#### ADDENDUM NO. 1

PROJECT: S&C # P160218; Stoddard County Road 488 Bridge

#### **SUBJECT: Project Manual Changes/Clarifications**

#### **SUBJECT: Project Plans Changes/Clarifications**

## ARCH PIPE DETAILS AND LAYOUT (ASPHALT)

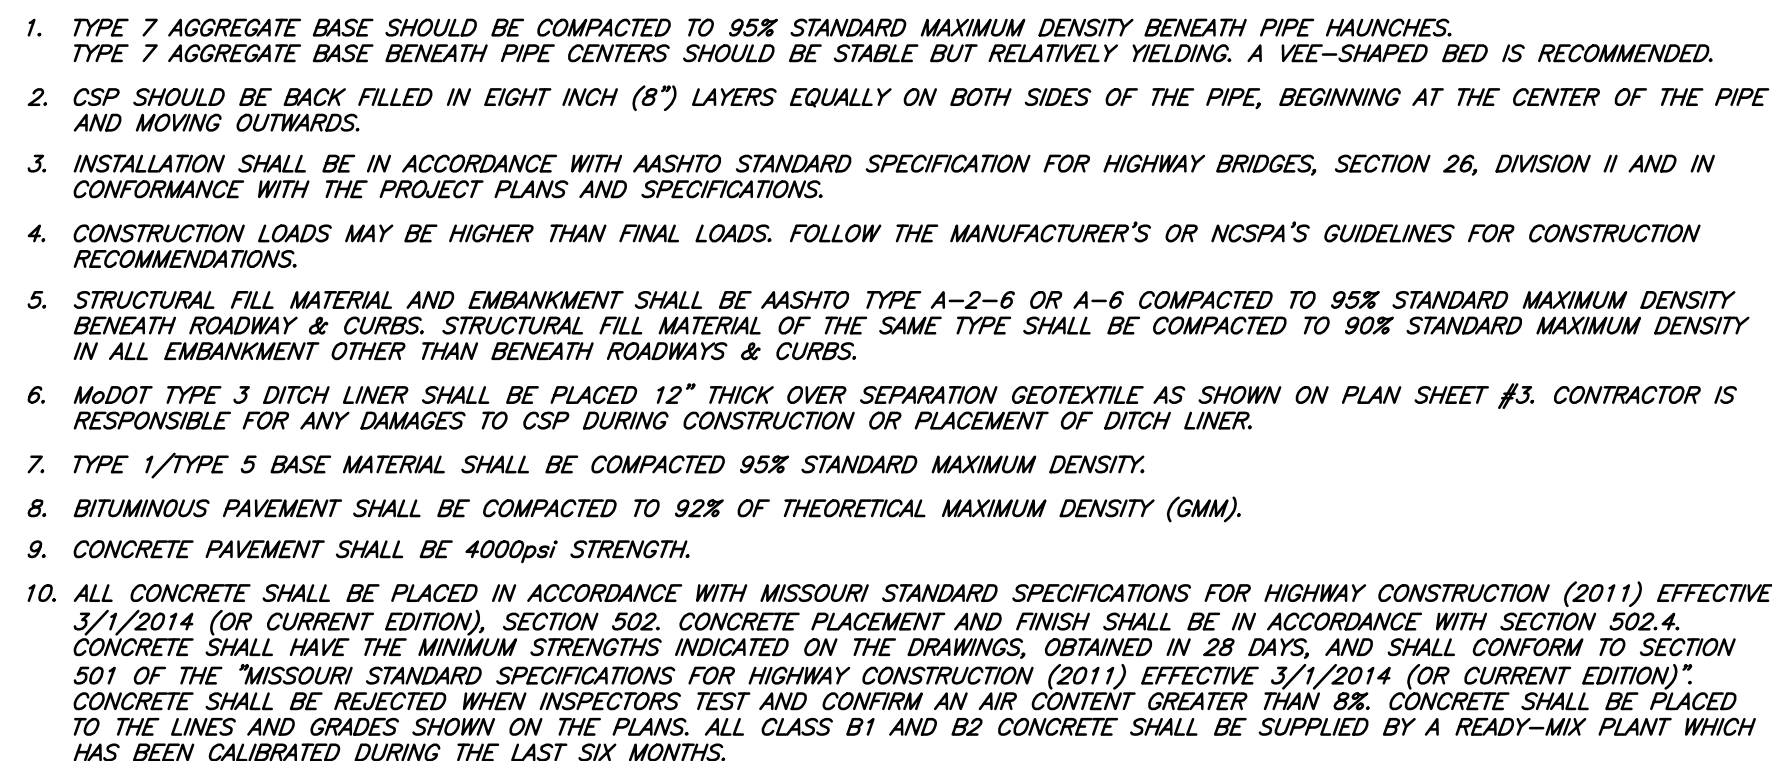
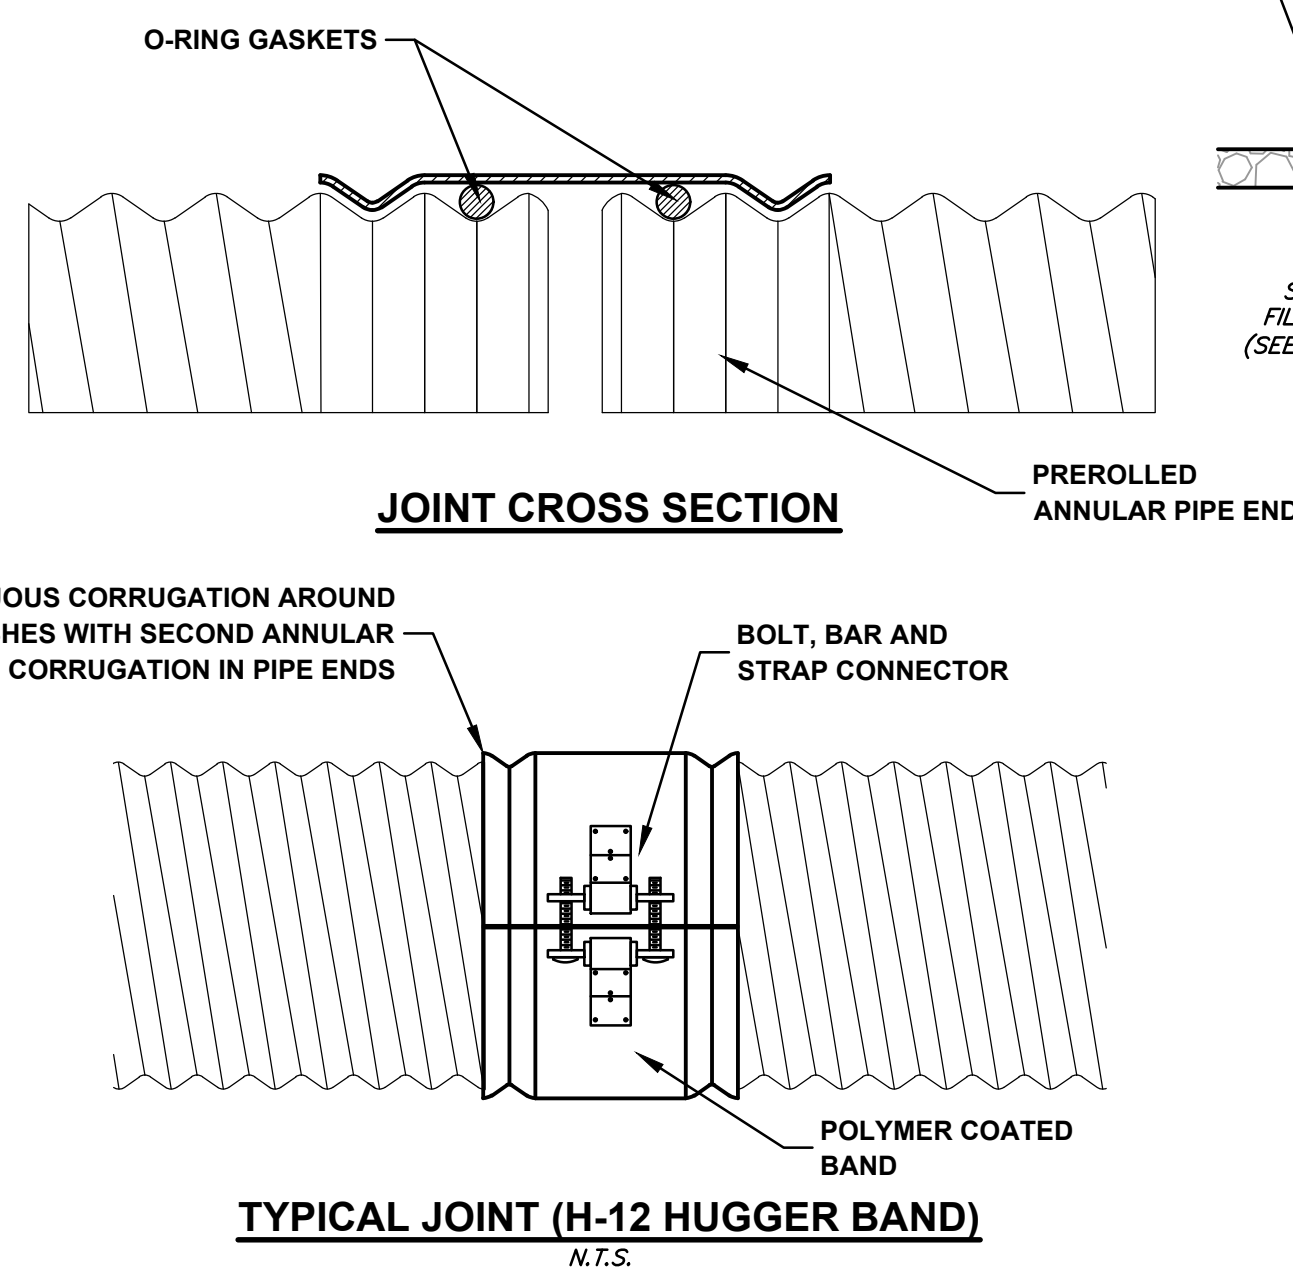
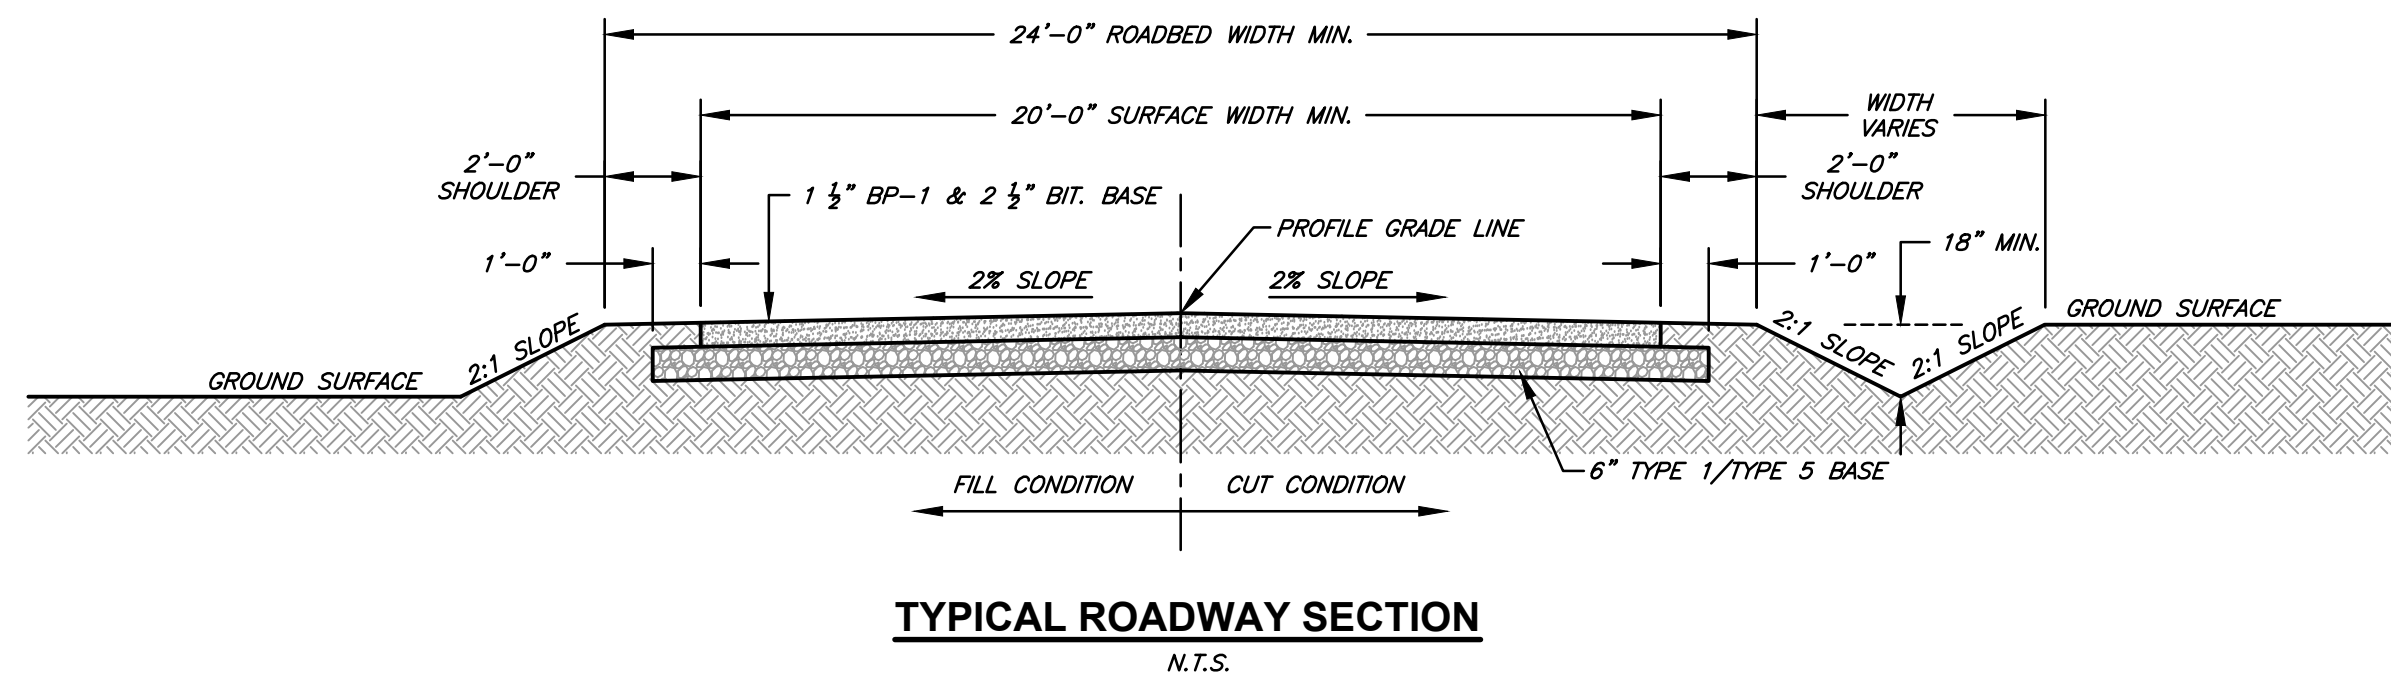
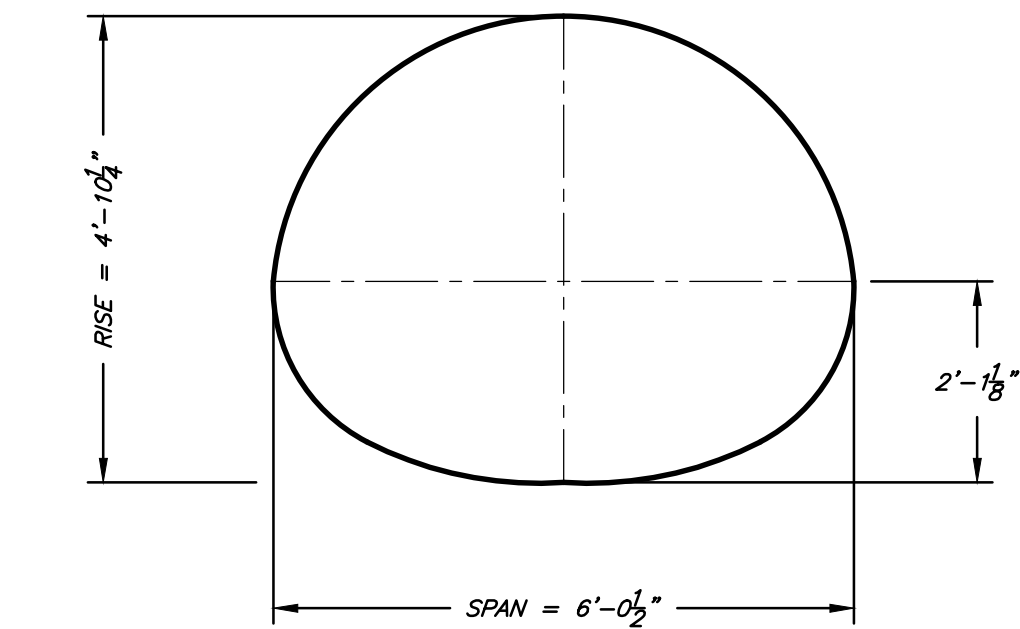
1. Sheet 4 – ARCH PIPE DETAILS AND LAYOUT
  - An additional detail was provided for the road details regarding the alternate paving. See attached sheet 4 and 4.1 for clarification.
